FINAL ENVIRONMENTAL IMPACT REPORT

SANTA ANA RIVER WATER RIGHT APPLICATIONS FOR SUPPLEMENTAL WATER SUPPLY

January 2007
SCH# 2002071062

Figure 3-1. Forward Particle Tracking of Perchlorate Plume - Changes between the Project Scenario A and No Project Conditions

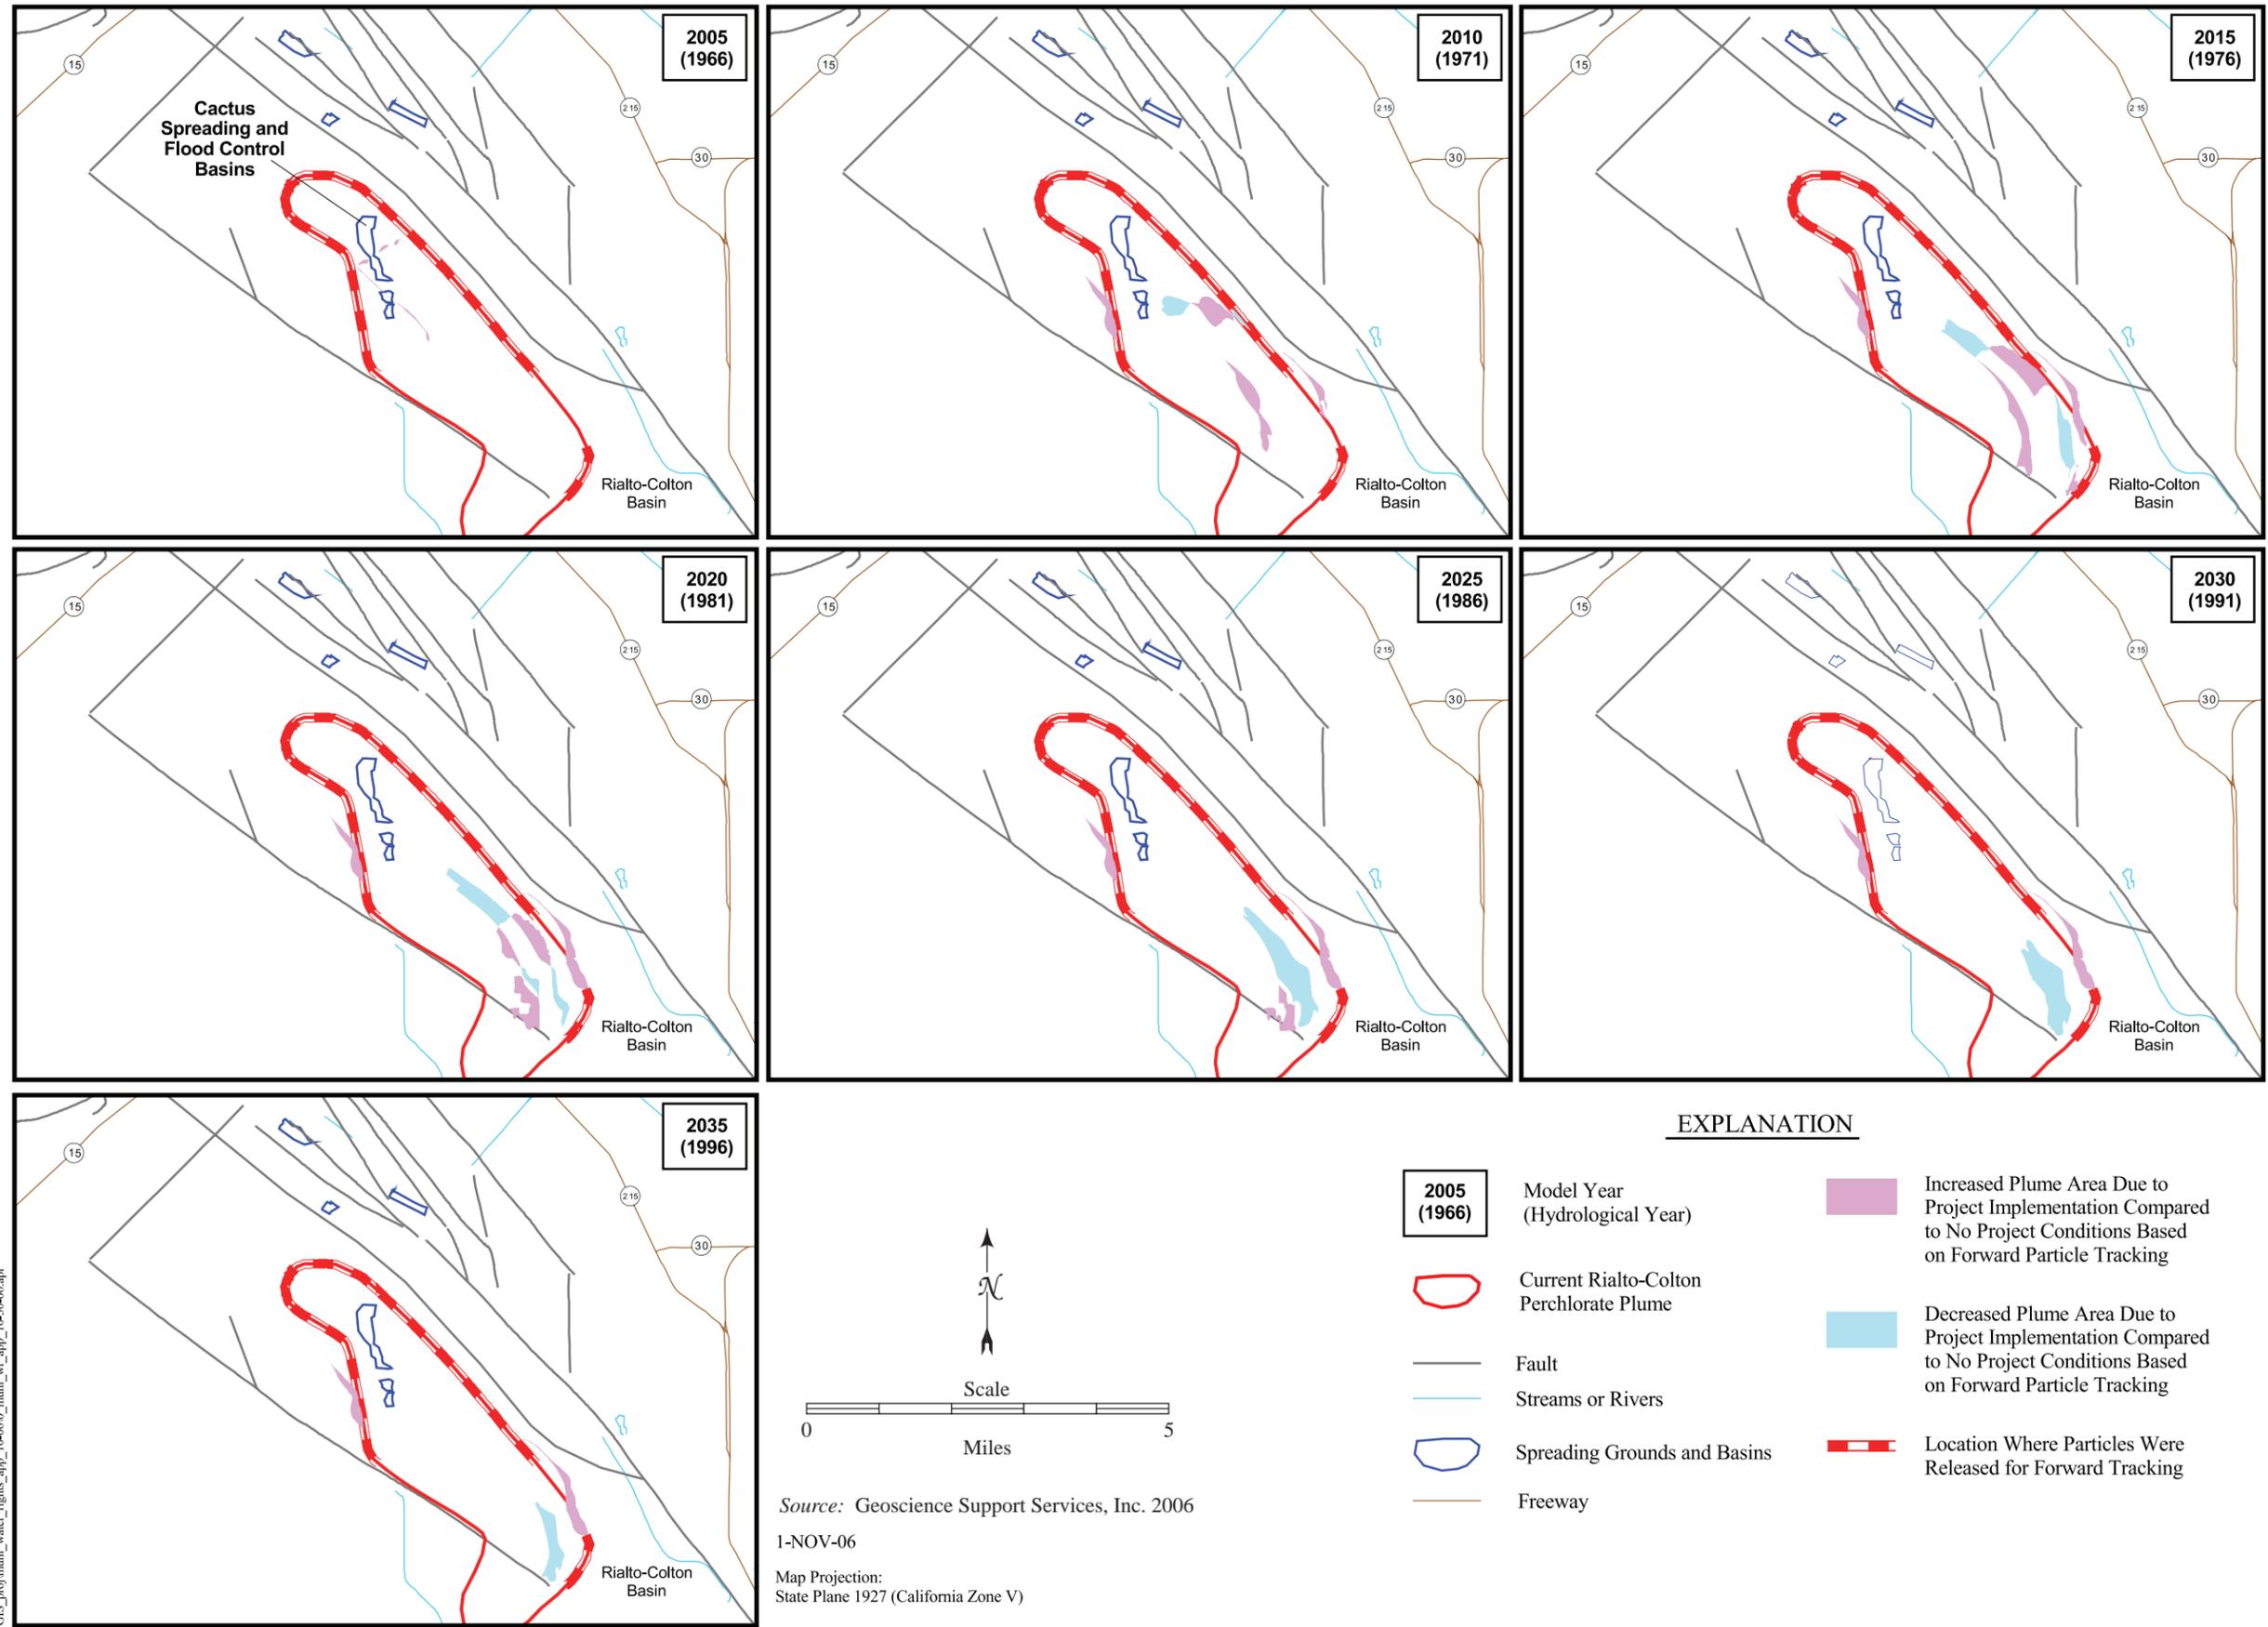
8 The Rialto-Colton Plume lies beneath the Cactus Basin spreading grounds and perchlorate
9 contamination is known to be currently transported in a southeasterly direction with
10 groundwater (Draft EIR Figure 3.12-1). Particle tracking simulations (Draft EIR Figure 3.2-13)
11 conducted by Woolfenden and Koczot (1999) show that mass transport proximal to the
12 spreading basins is consistent with the general trend of groundwater flow. Groundwater
13 elevation is known to fluctuate from year to year by as much as approximately 60 feet
14 (Kleinfelder 2003). Years of high precipitation may raise groundwater levels 40 or more feet
15 and the range of water levels through the 1990s for a well is typically about 50 feet (DWR 2003).

Page	Line(s)	Edit
		<p>MM HAZ-6: <u>Muni/Western shall not spread water diverted or stored pursuant to the Project in the Cactus Spreading and Flood Control Basins or other locations overlying the Rialto-Colton basin until Muni/Western have completed the development of a groundwater model of the Rialto-Colton basin that includes in its model output estimates of the impacts of the Project on groundwater contaminants. In the event that the model shows that the Project will cause the contamination of any well used to provide a source of potable water, Muni/Western will comply with the terms of MM HAZ-5 by providing an alternative source of potable water or treatment of affected wells during the period where the Project contributes to an exceedance of applicable water quality objectives.</u></p>

Figure 3-2. San Bernardino Valley Water Conservation District Annual Santa Ana River Diversions, WY 1914-15 through 1999-00

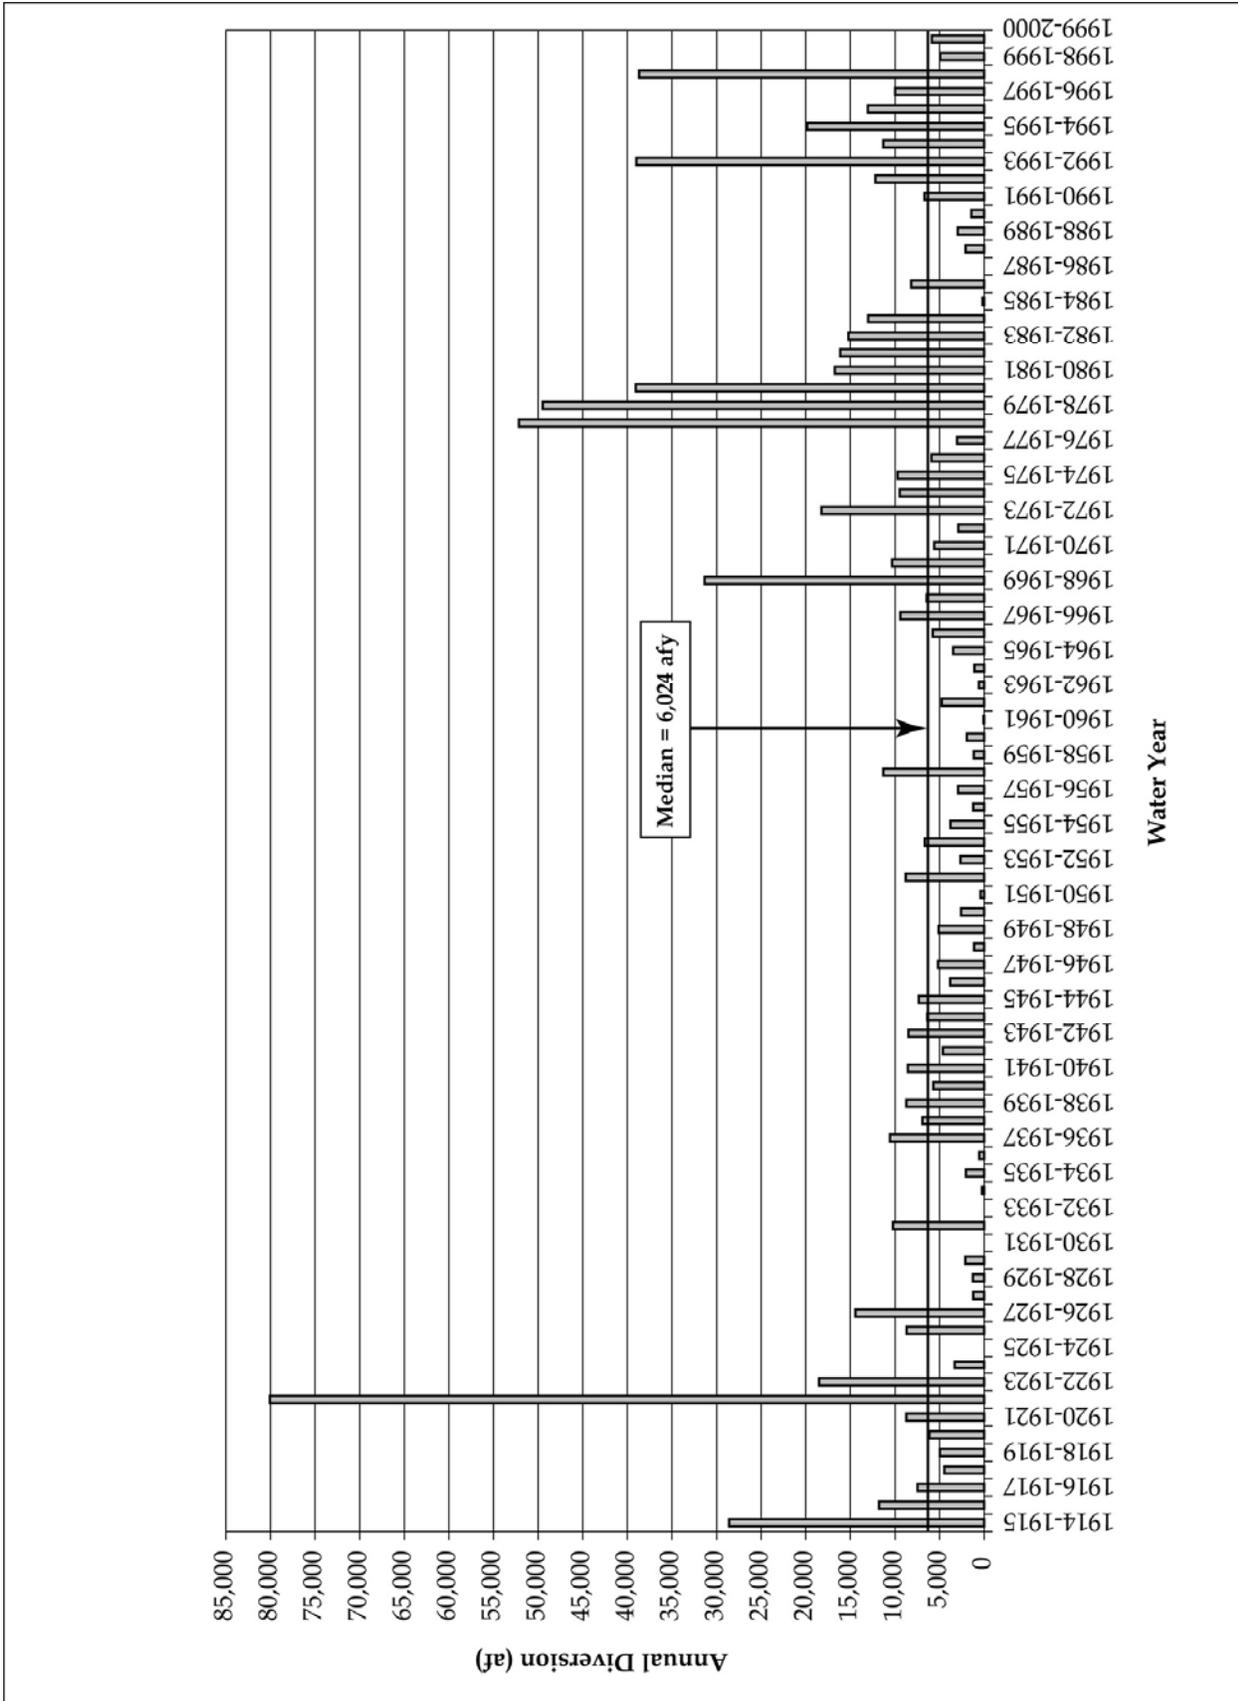
22 The Draft EIR does contain the Conservation District data for water year 1969-70, as shown in
23 Figure 2.4-1; however, it appears the water year 1969-70 was left out of the text description in
24 section 2.4.5 that compares Conservation District spreading before and after water year 1968-69.
25 A check on the data record verifies that Conservation District spread 31,354 acre-feet in water
26 year 1968-69 not in water year 1969-70 as suggested in the comment. Section 2.4.5 has been
27 updated to include discussion of the 1969-70 water year and to include reference to data from
28 water year 1914-15 through 1999-00 (see below).

Page	Line(s)	Edit
A-2-20	24-30	Conservation District diversions are measured below the North Fork Box and include the total of diversions made at the Cuttle Weir and waters from the North Fork Box. A histogram showing historical Conservation District diversions of SAR water for the period 1914-15 through 1998-99 <u>1999-2000</u> is presented in Figure 2.4-1. Diversions by the Conservation District have averaged 9,870 af <u>9,847 af</u> annually over the period of record, with median annual diversions being 6,145 af <u>6,024 af</u> . For the period WY 1915-16 <u>1914-15</u> to WY 1968-69 <u>1969-70</u> Conservation District diversions averaged 7,337 af <u>7,390 af</u> ; <u>for the period after the Western Judgment became effective from WY 1970-71 <u>1969-70</u> to 1999-2000 diversions averaged 14,896 af <u>14,299 af</u>.</u>
		<i>Replace Appendix A Figure 2.4-1 (see replacement Figure 3-2)</i>

Figure 3.1-7. Probability of Daily Discharge for SAR Segment B, above Cuttle Weir, WY 1966-67 through WY 1999-2000

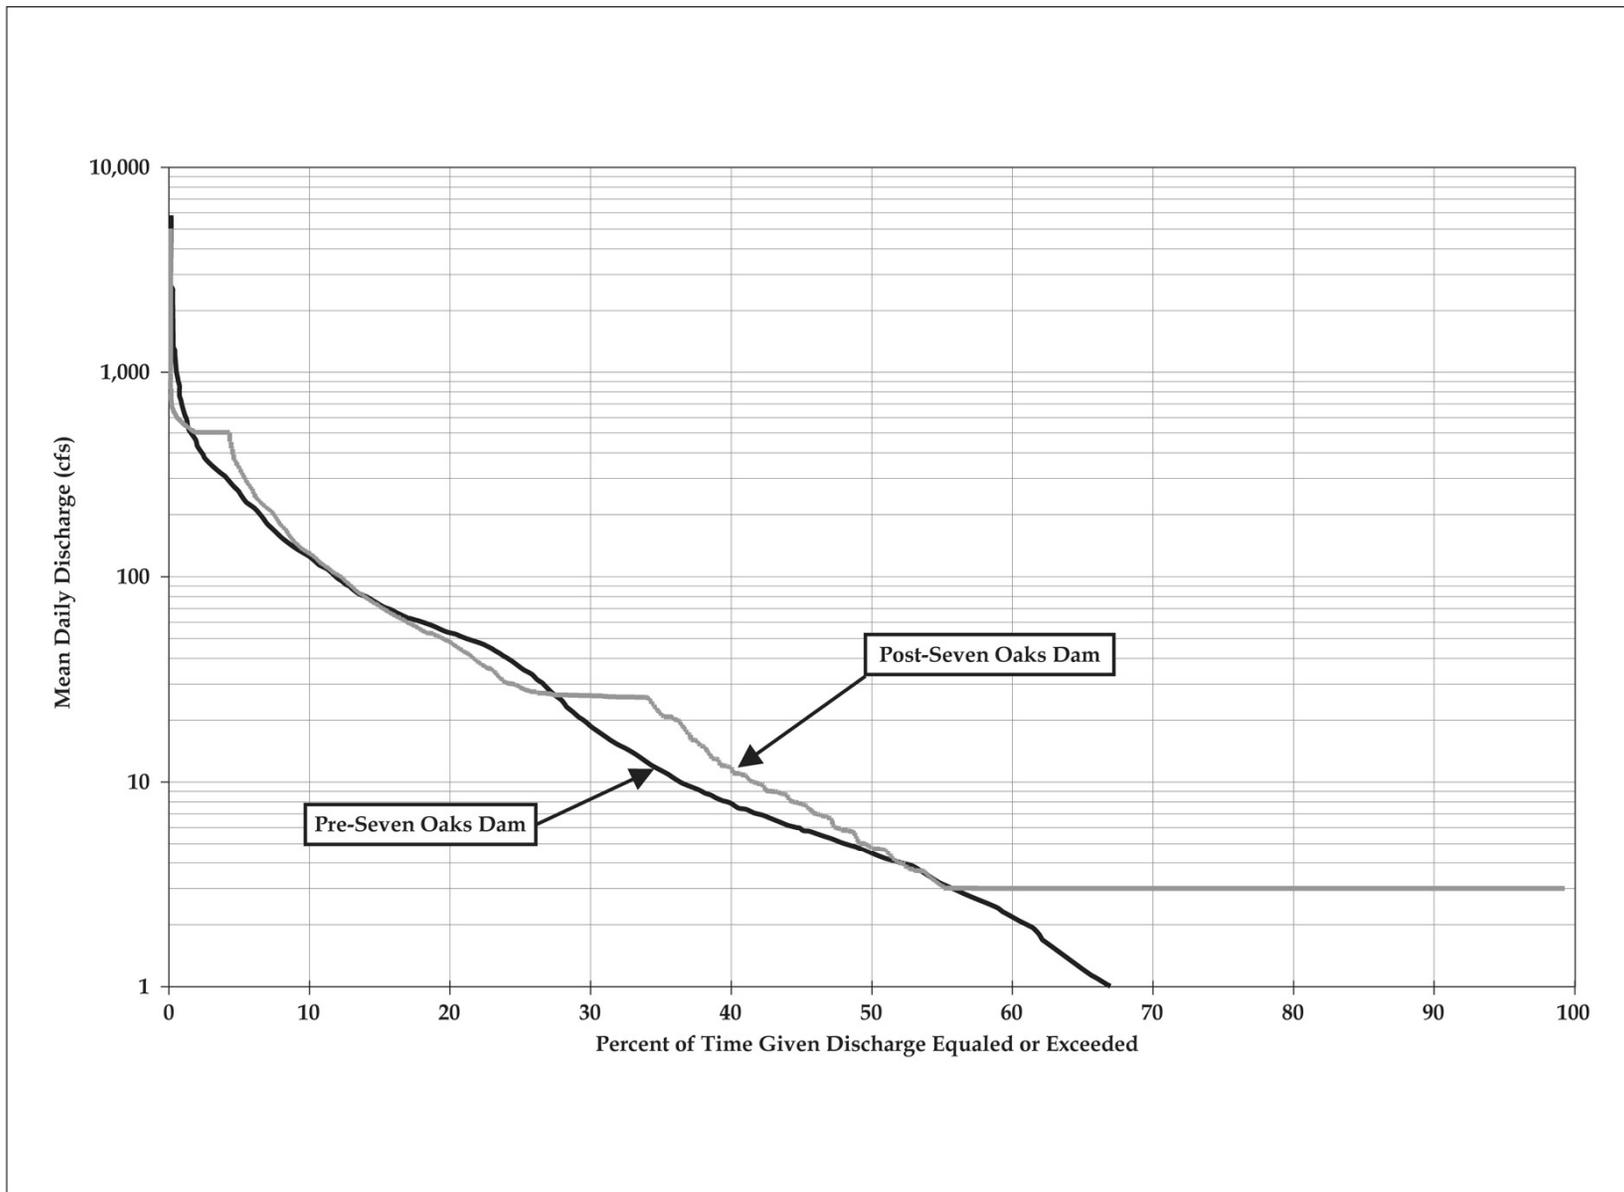
14 Figure 3.1-7 of the Draft EIR shows probability of exceedance curves for flow above Cuttle Weir
15 that are based on nearby gage data with adjustments made for upstream diversions. [Note to
16 the reader: due to refinements in the modeling, Draft EIR Figure 3.1-7 has been replaced. See
17 the replacement figure provided in Appendix A of this Final EIR.] It is evident from this figure
18 that prior to the construction of Seven Oaks Dam, virtually no flow (less than 1 cfs) was present
19 in this segment about 30 percent of the time, flows above 10 cfs occurred approximately 35
20 percent of days, and flows above 100 cfs were rare, occurring only about 10 percent of the time.
21 With the dam in operation, daily discharge is at least 3 cfs, and about 55 percent of the time
22 discharge is greater than 3 cfs. For this segment of the SAR, with the dam in operation, a daily
23 discharge of 10 cfs is equaled or exceeded approximately 40 percent of the time, while for flows

Figure 3.1-8. Probability of Daily Discharge for SAR Segment C, below Cuttle Weir, WY 1966-67 through WY 1999-2000

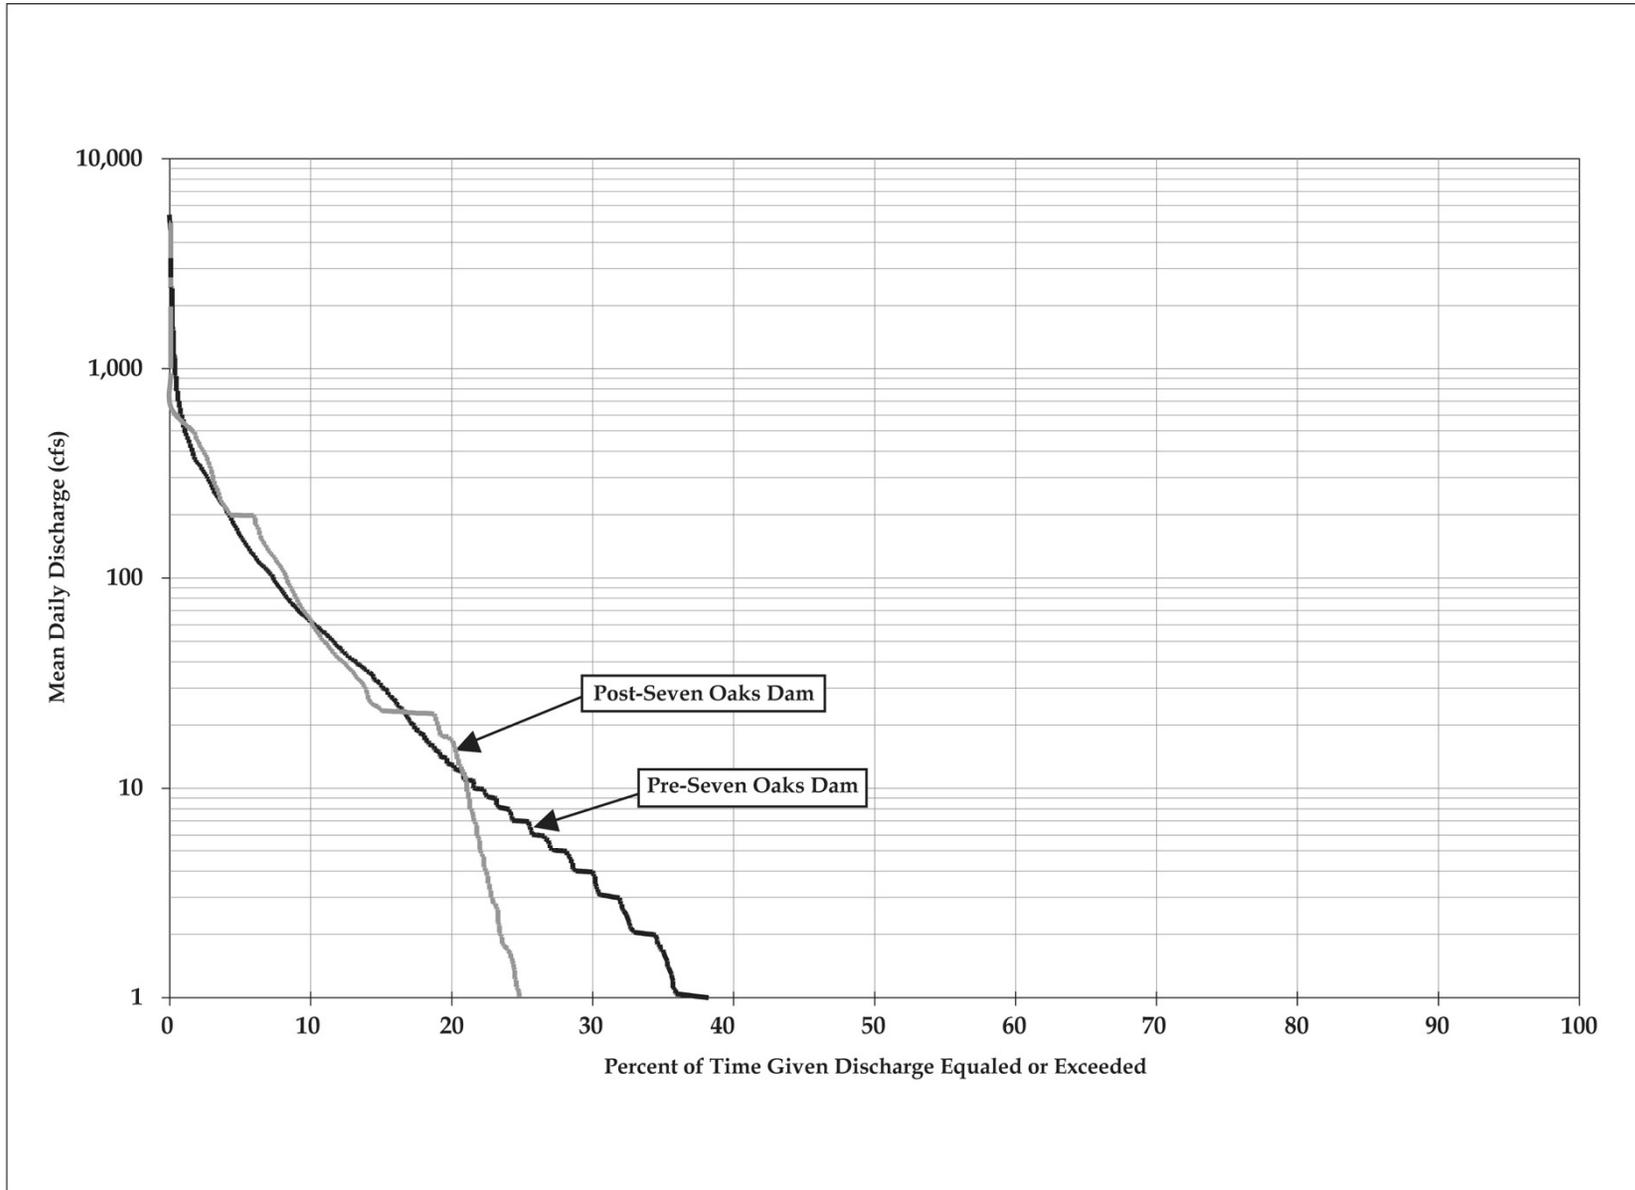
33 Figure 3.1-8 in the Draft EIR shows probability of exceedances curves for flow downstream of
34 Cuttle Weir. [Note to the reader: due to refinements in the modeling, Draft EIR Figure 3.1-8 has
35 been replaced. See the replacement figure provided in Appendix A of this Final EIR.] Prior to
36 the construction of Seven Oaks Dam, virtually no flow was present in this segment about 65
37 percent of the time, flows above 10 cfs occurred just over 20 percent of days, and flows above
38 100 cfs occurred about 8 percent of the time. With the dam in operation, little or no discharge
39 occurs in this river segment almost 75 percent of the time. With the dam in operation a daily
40 discharge of 10 cfs is equaled or exceeded approximately 22 percent of the time, while for flows
41 of 100 cfs and higher, the frequency drops to about 8 percent.
